Access Compliance Report

Public Rights-of-Way

Intersection ID: 10021978	Main Street: BROOKSVALE_ST	Cross Street: N/A	Location: NE
ADA ID: 9D95B8DC0309	Ramp Type: Perp	Initial Pass/Fail: Fail	Overall Compliance: No
		Severity Score: 12.5

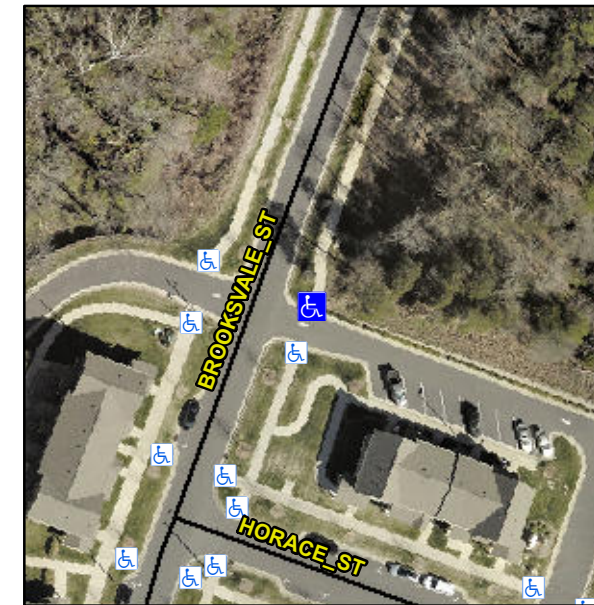
Not Found, R304.2.2

Compliance	Description	Data	Compliance	Description	Data
N/A	Ramp Length (in)	68.0	No	Ramp Slope (%)	8.6
Yes	Ramp Width (in)	71.0	Yes	Ramp XSlope (%)	0.4
N/A	Flare Type LT	N/A	N/A	Flare Type RT	N/A
N/A	Flare Slope LT (%)	N/A	N/A	Flare Slope RT (%)	N/A
N/A	Flare Traversable LT?	N/A	N/A	Flare Traversable RT?	N/A
N/A	Landing Length (in)	N/A	N/A	DWS Provided?	N/A
N/A	Landing Width (in)	N/A	N/A	DWS Contrast?	N/A
N/A	Landing Slope (%)	N/A	N/A	DWS Length (in)	N/A
N/A	Landing X Slope (%)	N/A	N/A	DWS Full Width?	N/A
N/A	Landing Curb? (Y/N)	N/A	N/A	DWS Offset (in)	N/A
N/A	Shared Landing?	N/A			
N/A	Gutter Ponding?	N/A	N/A	Gutter Slope (%)	N/A
N/A	Gutter Lip Ht (in)	N/A	N/A	Gutter X Slope (%)	N/A
N/A	Painted X Walk1?	No	N/A	Painted X Walk2?	N/A
	X Walk 1 Direction	To SW		X Walk 2 Direction	N/A
N/A	X Walk 1 Width (in)	N/A	N/A	X Walk 2 Width (in)	N/A
	X Walk 1 Slope (%)	0.2		X Walk 2 Slope (%)	N/A
	X Walk 1 X Slope (%)	3.2		X Walk 2 X Slope (%)	N/A

Remove & Replace Entire Ramp.
